产品图 Product drawing

产品名称 Item name	S09.01.01.134V2 TESLA-IP-24-60	产品材质 Product material	PC
图法 View	第三视角	设计 Designed by	YeJingsi
比例 Scale	1:1	审核 Checked by	Eric
单位 Unit	MM	批核 Approved by	Eric

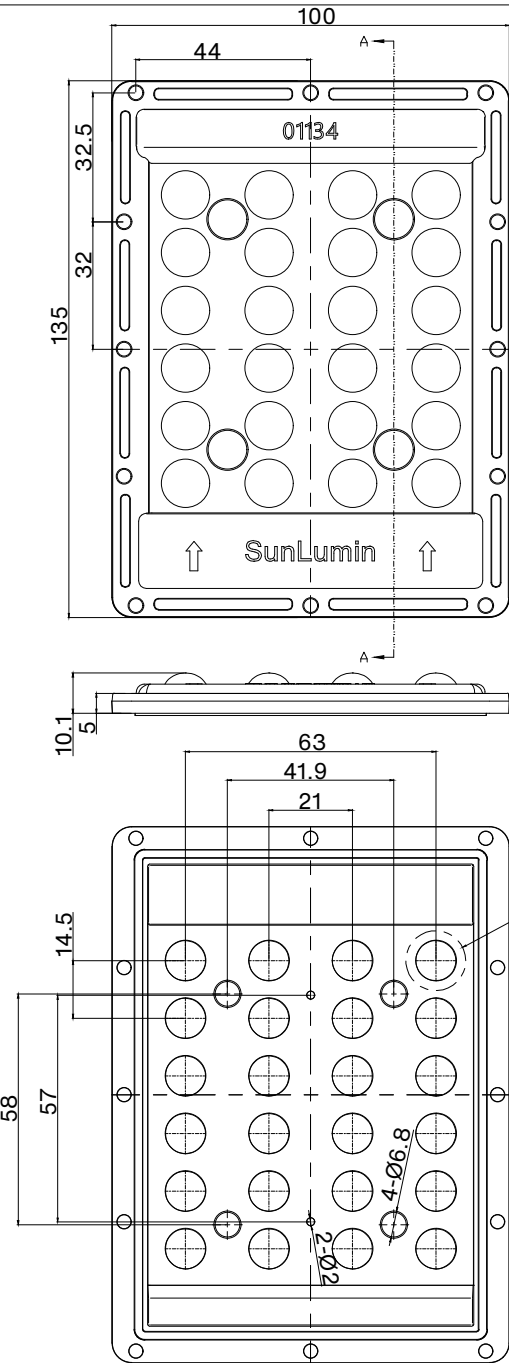
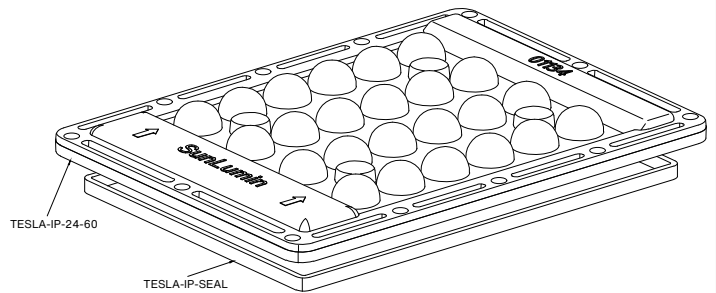
版本 REV	日期 DATE	变更内容 CHANGE (ITEM)
A1	2026-3-30	A1标记处螺丝孔结构变更/后模光学直径变更/硅胶圈结构变更
A2	2026-6-9	A2标记处硅胶圈结构变更
